This Addendum forms a part of the contract documents. It modifies them as follows:

END OF ADDENDUM NO. 2

**NUTTER HALL  
 RENOVATIONS**  
 FAIRFIELD, MAINE

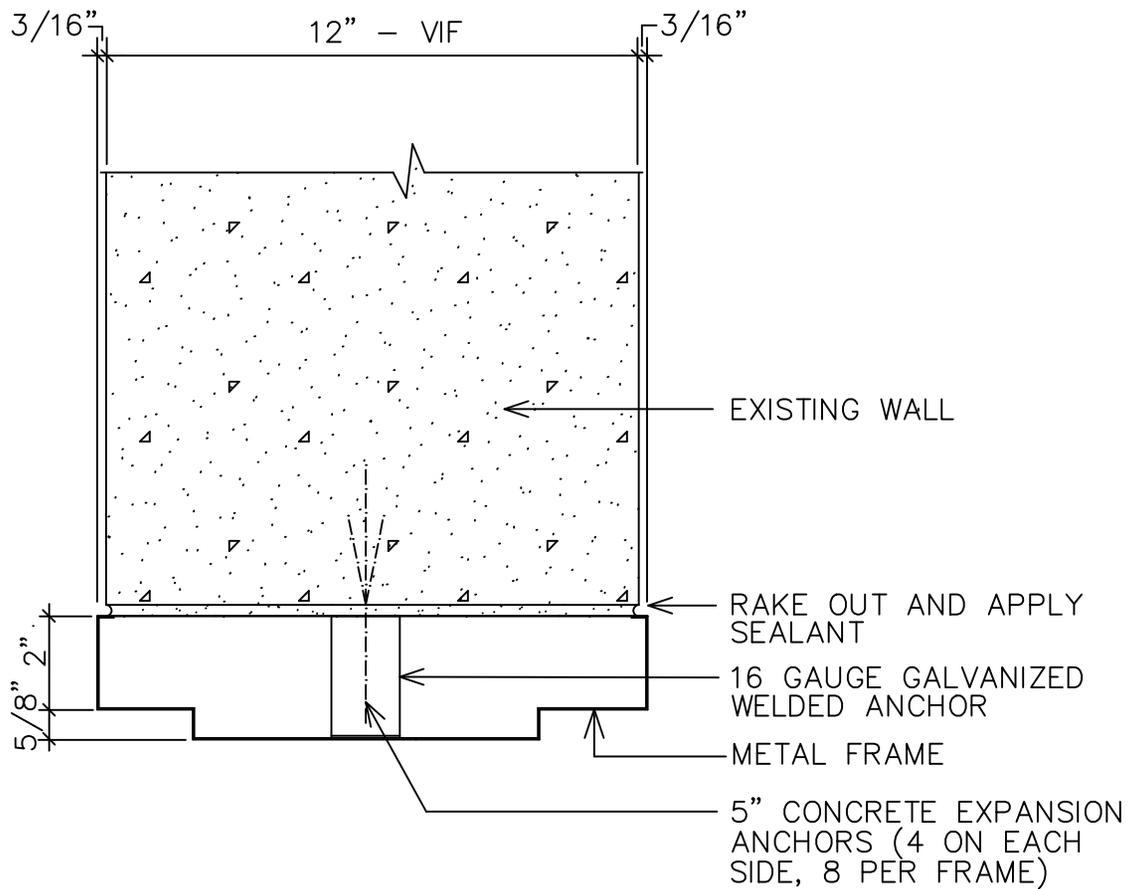
23 35 13 DUST COLLECTION SYSTEM - 2.2.H. Accessories: ADD the following after 1. Drum sentry:

2. EXPLOSION-PROTECTED HOUSING CONSTRUCTION: Welded and bolted 14 and 16 gauge mild steel construction and rated for -16"wg. One 1" NPT sprinkler port with plug is provided in the upper front center of each filter module. Includes explosion vent. 56" x 26" membrane style side-mounted explosion vent limits overpressure in the event of a deflagration in order to maintain the structural integrity of the collector. Maximum Kst value is: 300 (based on NFPA-68-2007, without ducting after relief panels. UMA 450 P-red: 0.3 BAR.

**SK-9**

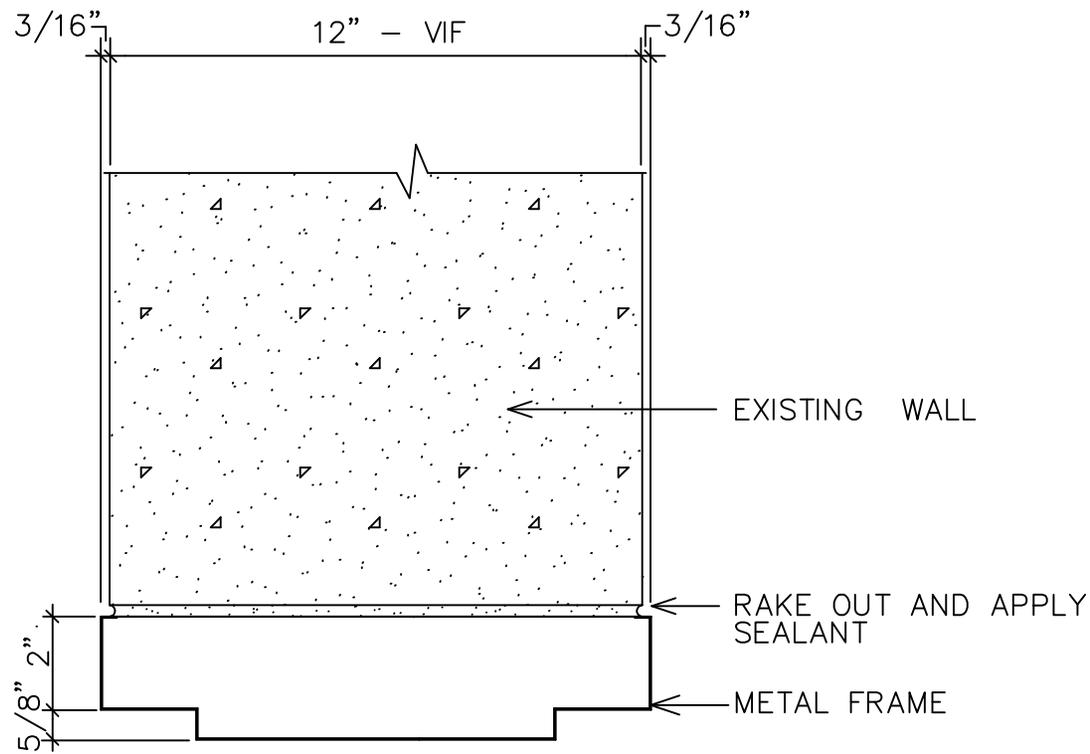
A4 REPLACE jamb detail labelled "9/A5" in the door schedule for doors 10, 16, and 27 with jamb detail shown on SK-9.

<b>LEWIS + MALM ARCHITECTURE</b> 124 MAIN STREET, BUCKSPORT, MAINE 04496 PHONE: (207) 469-7440 FAX: (207) 469-2181
<b>NUTTER HALL RENOVATIONS</b> FAIRFIELD, MAINE
<b>DOOR HEADER</b>
<b>JOB# 1438</b>
DATE: 06AUG2015
REF: A5 <b>SK-10</b>

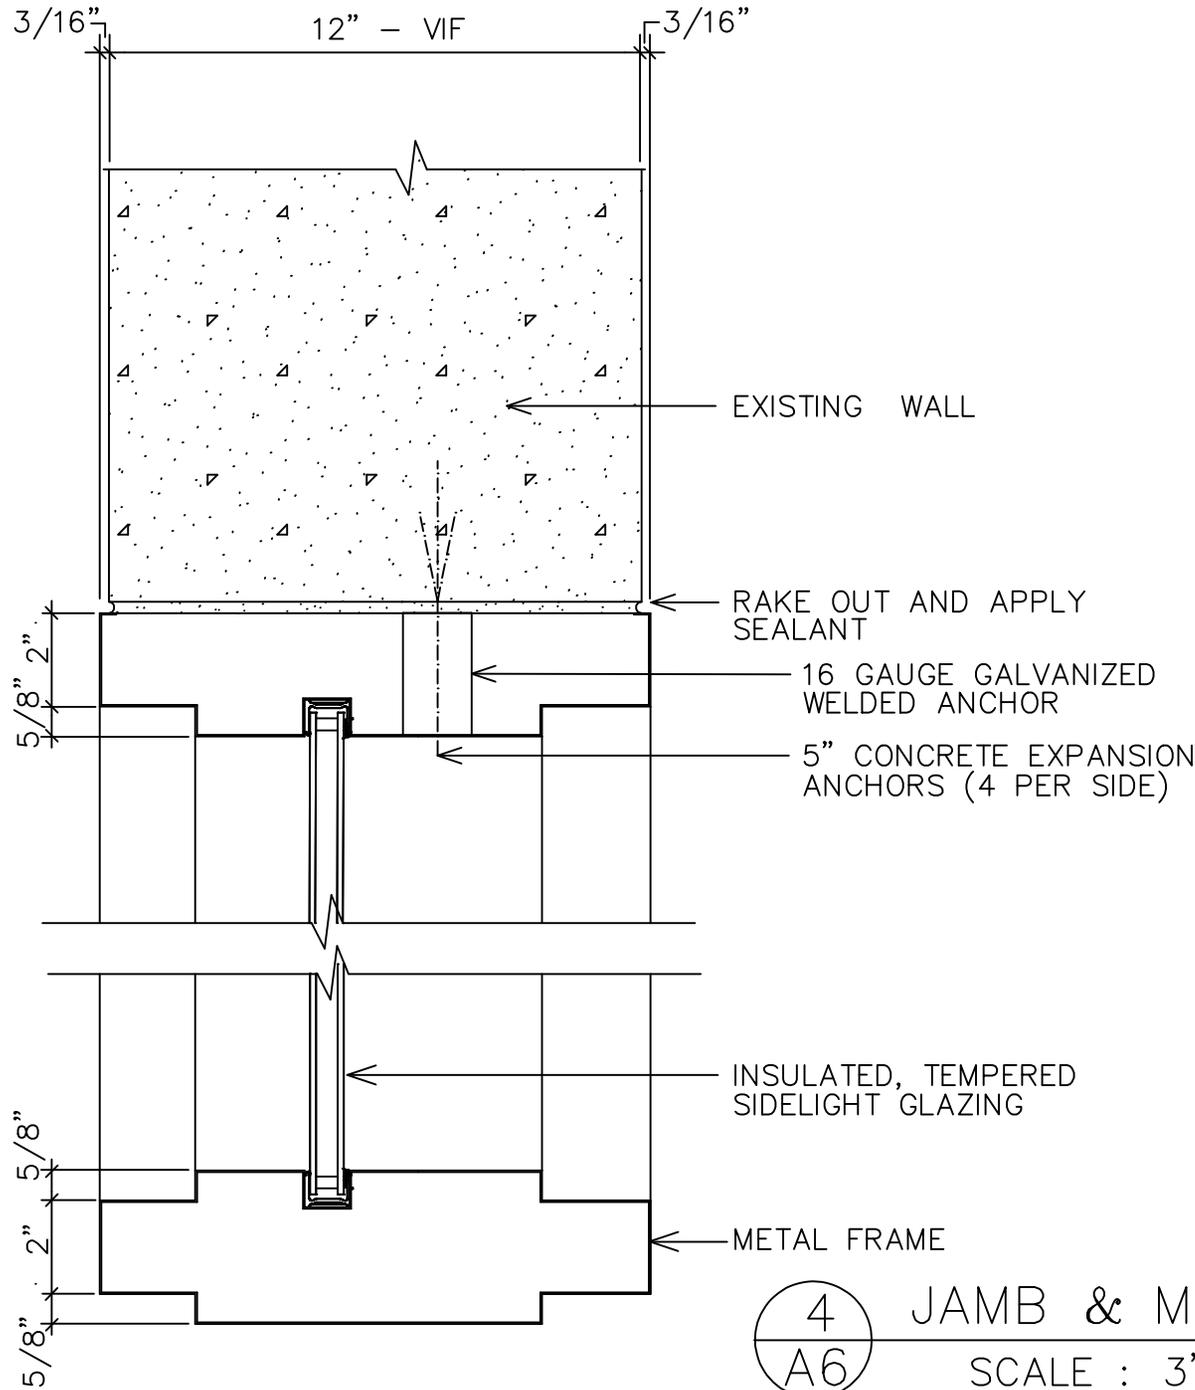
A4 REPLACE head detail labelled "4/A5" in the door schedule for doors 10, 15, 16, and 27 with head detail shown on SK-10.
